CORPS OF ENGINEERS

2-1-50	CORRECTED DWG. NO. — ADDENDUM NO. 2
REVISION	DATE
DESCRIPTION	
CORPS OF ENGINEERS U. S. ARMY OFFICE OF THE DISTRICT ENGINEER HUNTINGTON, W. VA.	
DRAWN BY: E.S.W.	TUSCARAWAS RIVER LOCAL PROTECTION PROJECT MASSILLON, OHIO SIPPO CREEK PUMP STATION LOCATION PLAN & PROFILES
TRACED BY: L.L.L.	
CHECKED BY: M.W.W.	
APPROVED BY: J. E. Johnson	
DATE: DEC. 1949	DATE: DEC. 1949
SCALE: AS SHOWN	SPEC. NO.
DRAWING NUMBER 0271-PM-51.3/1	SHEET 25 OF 42

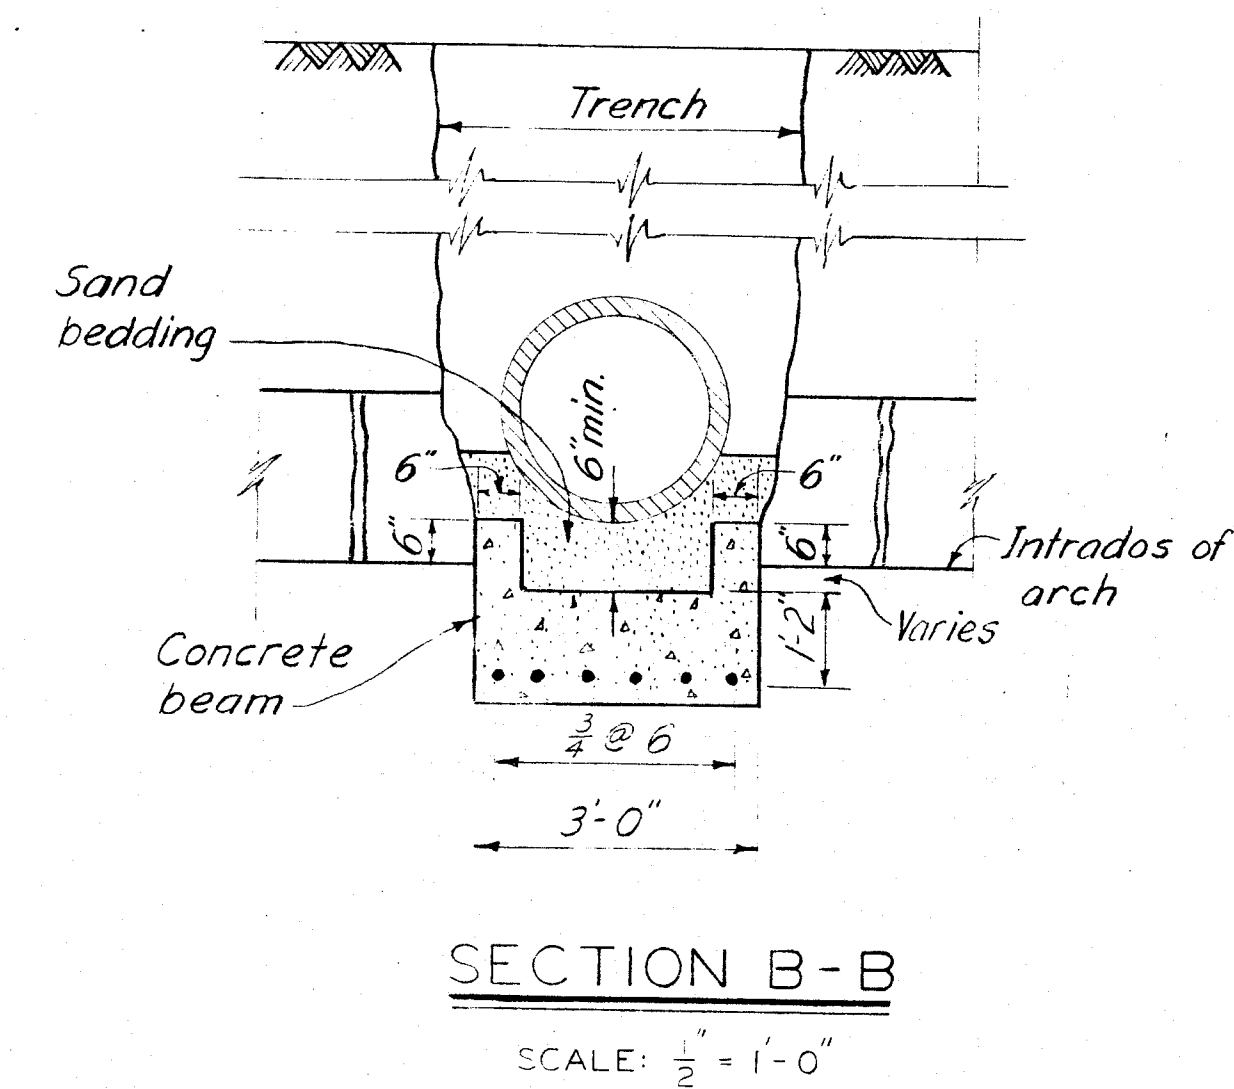
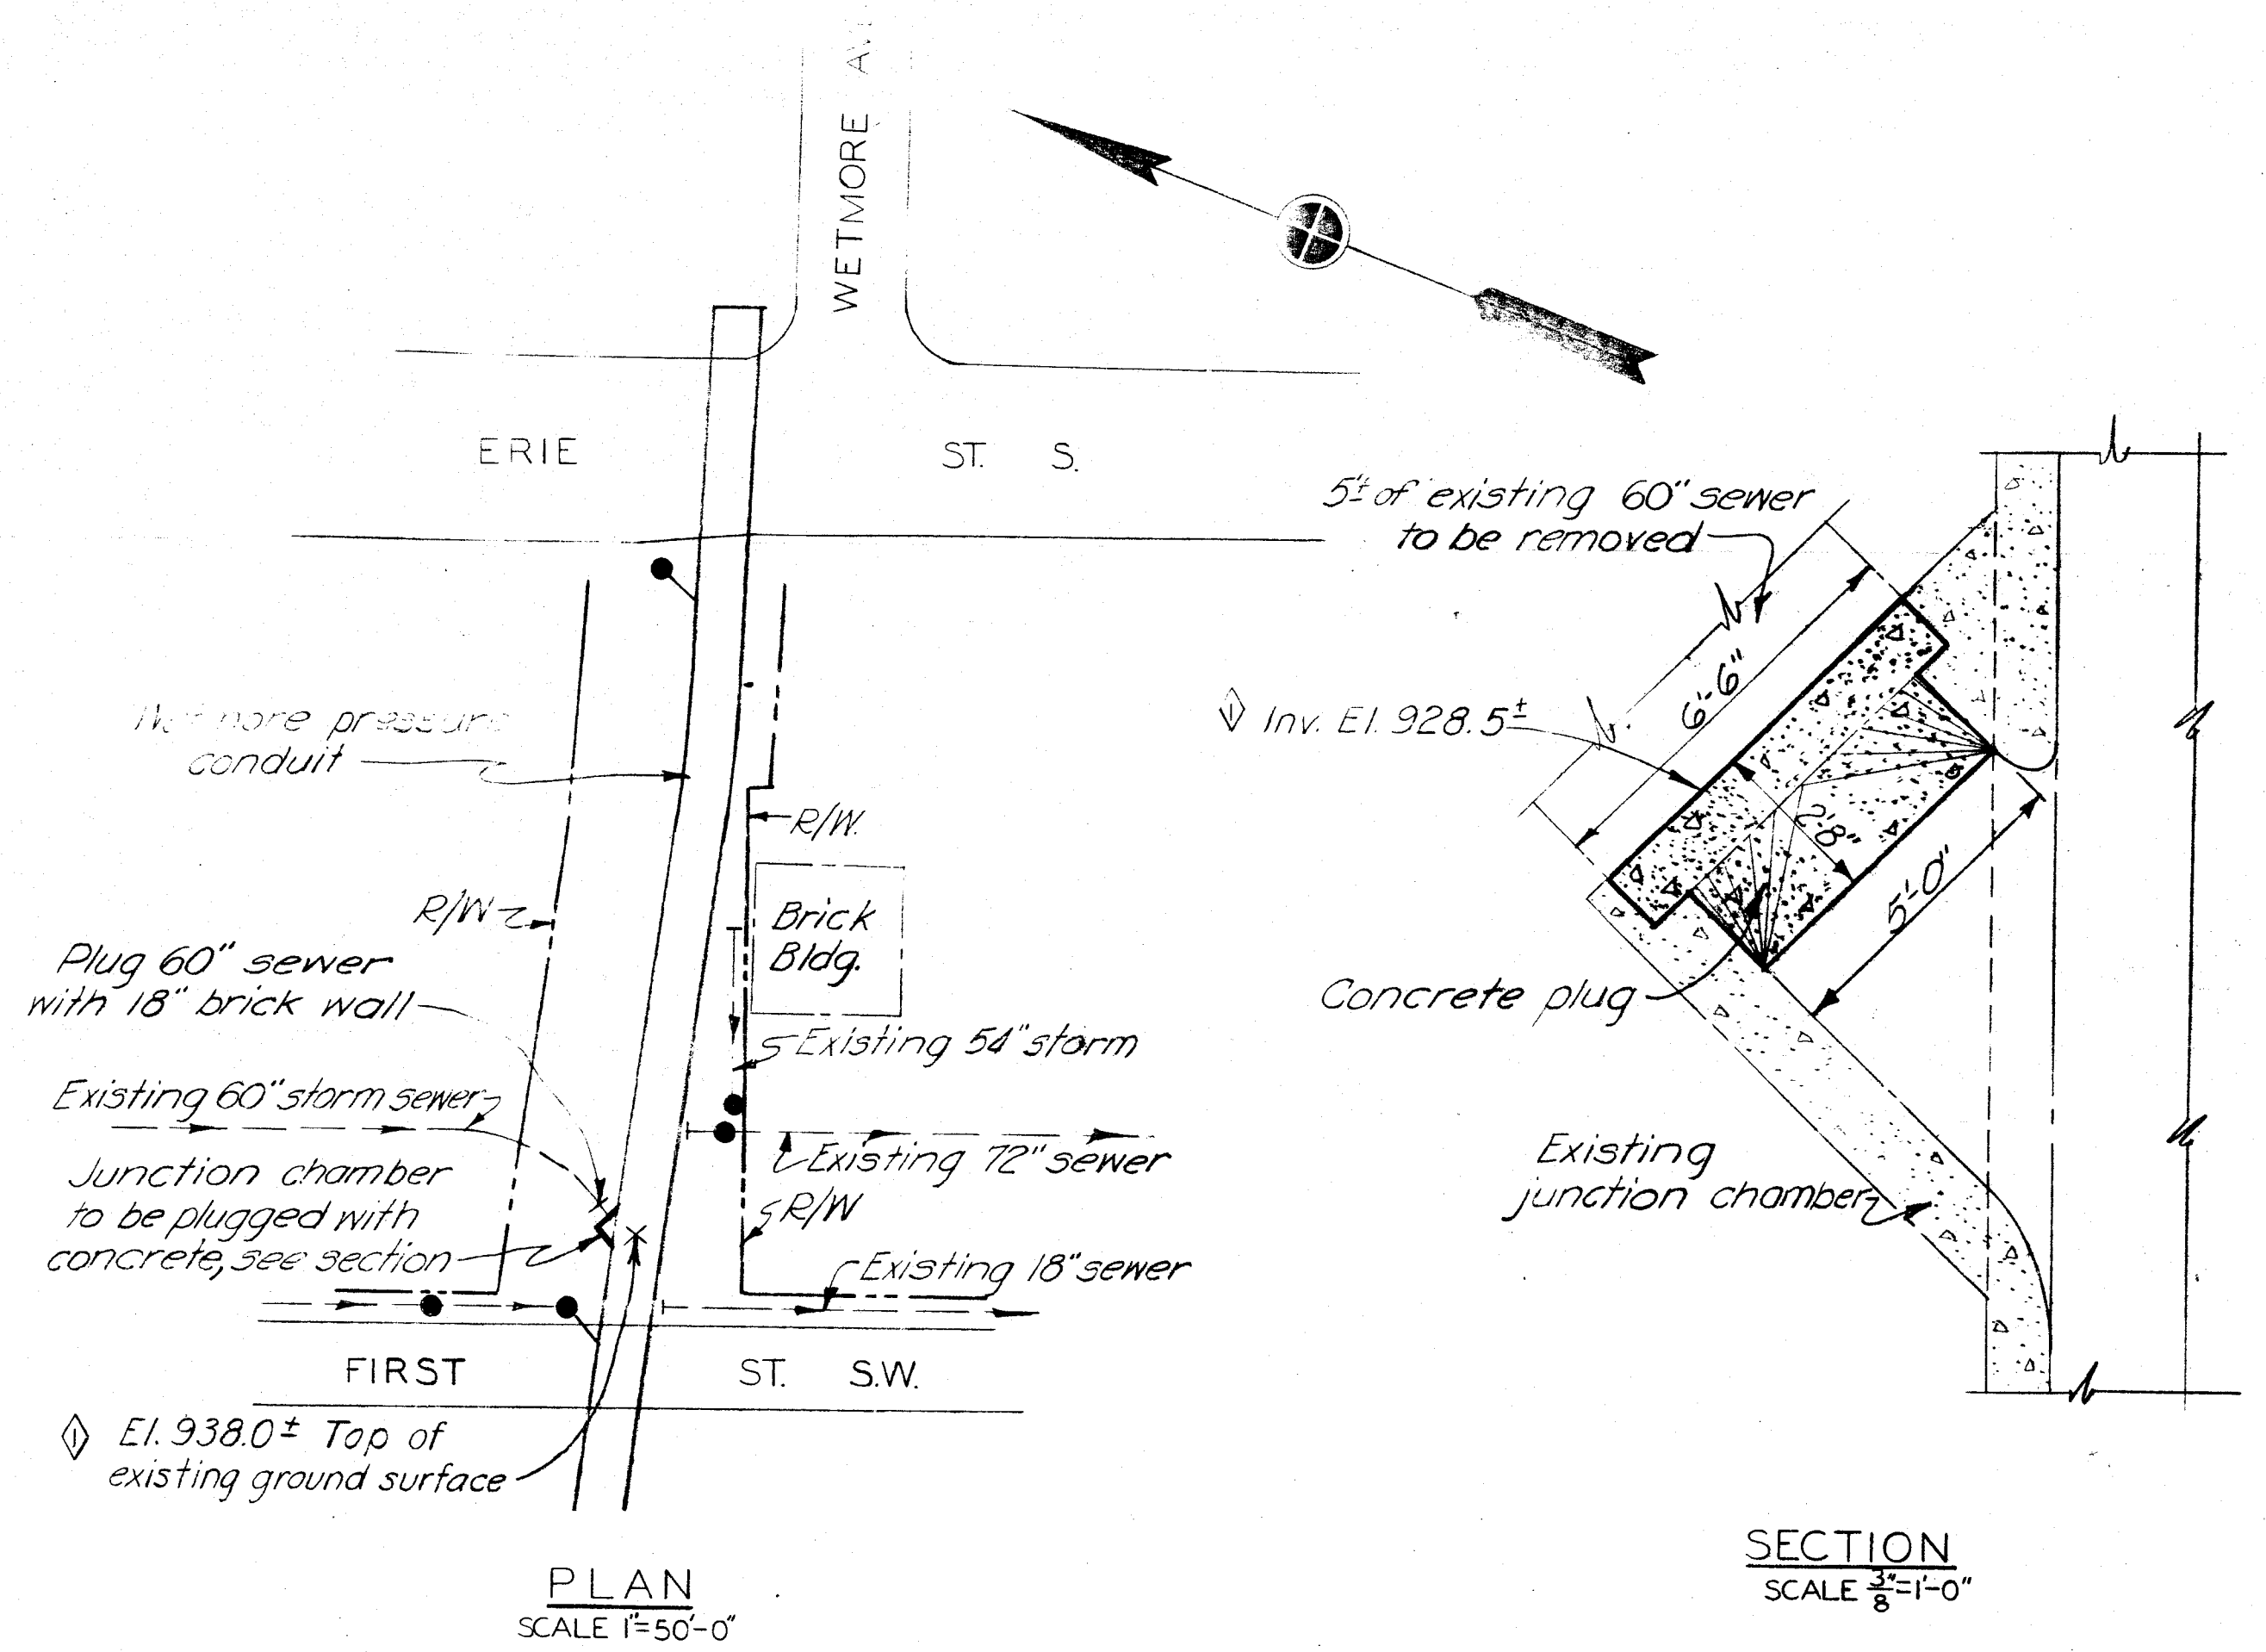
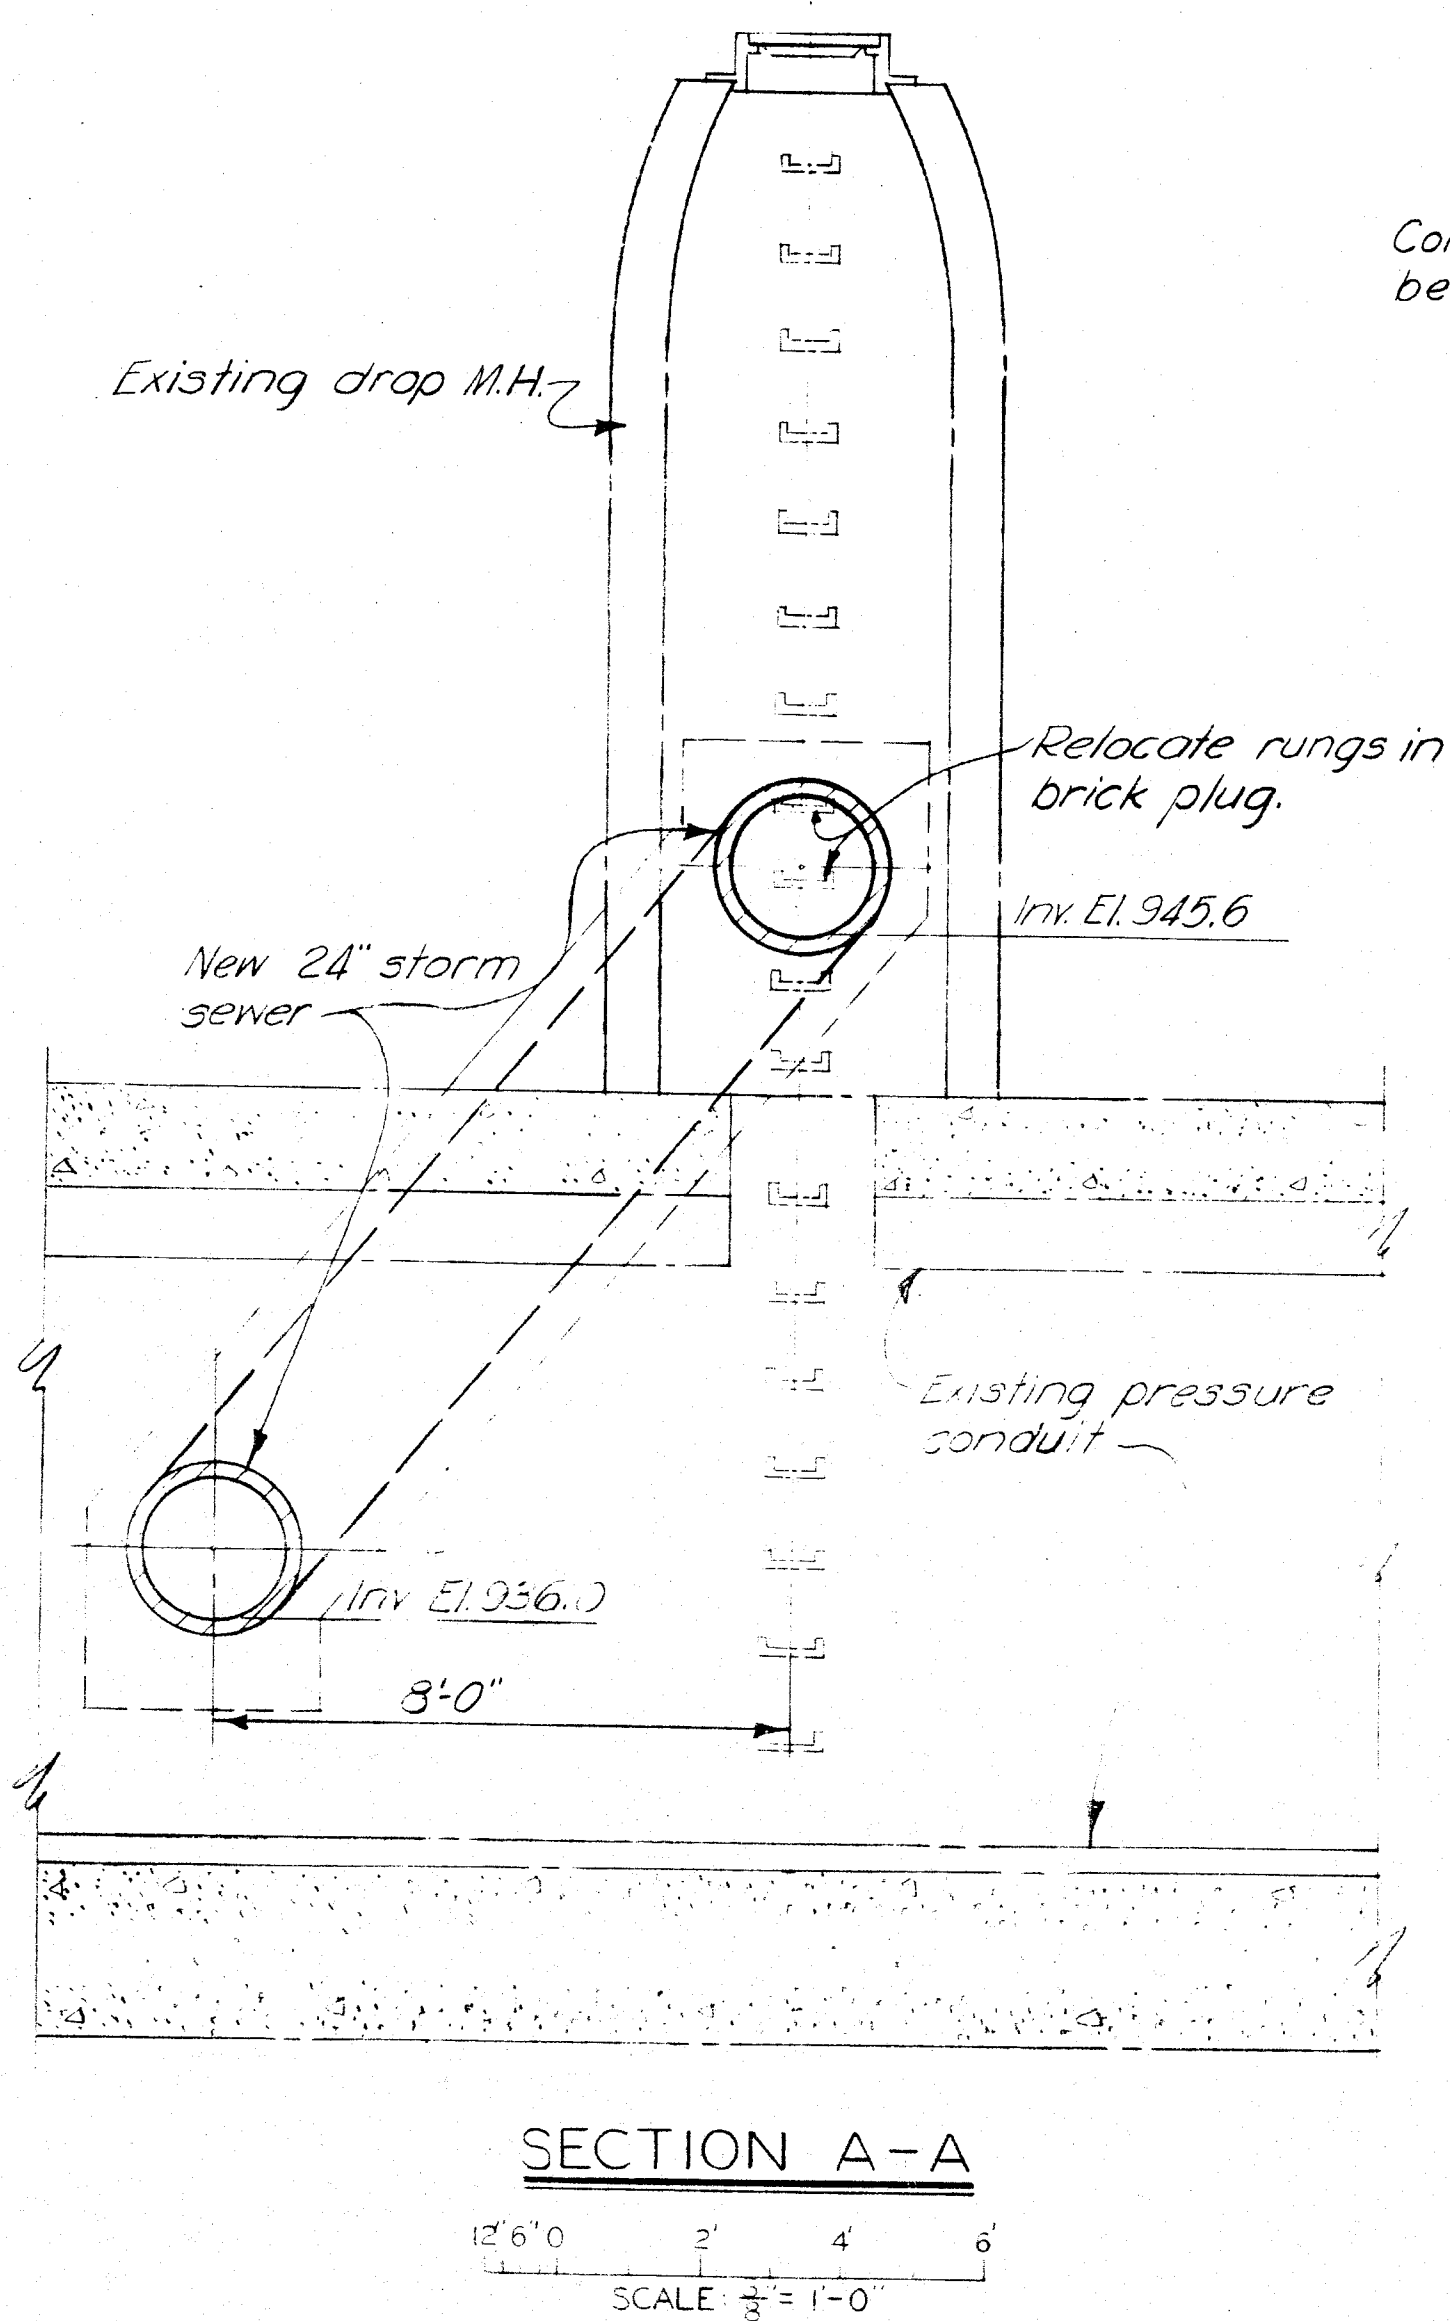
2-1-50	ADDED ELEVATIONS OF TOP OF GROUND AND INVERT OF SEWER - ADDENDUM NO. 1	K.S.B.
REVISION DATE	DESCRIPTION	BY
CORPS OF ENGINEERS U. S. ARMY OFFICE OF THE DISTRICT ENGINEER HUNTINGTON, W. VA.		
TUSCARAWAS RIVER LOCAL PROTECTION PROJECT MASSILLON, OHIO SIPPO CREEK PUMP STATION ALTERATIONS		
DRAWN BY: E.W.H.-L.L.L.	DATE: DEC. 1949	
TRACED BY: L.L.L.	SPEC. NO.	
CHECKED BY: M.D.-M.W.W.	DRAWING NUMBER -513/9
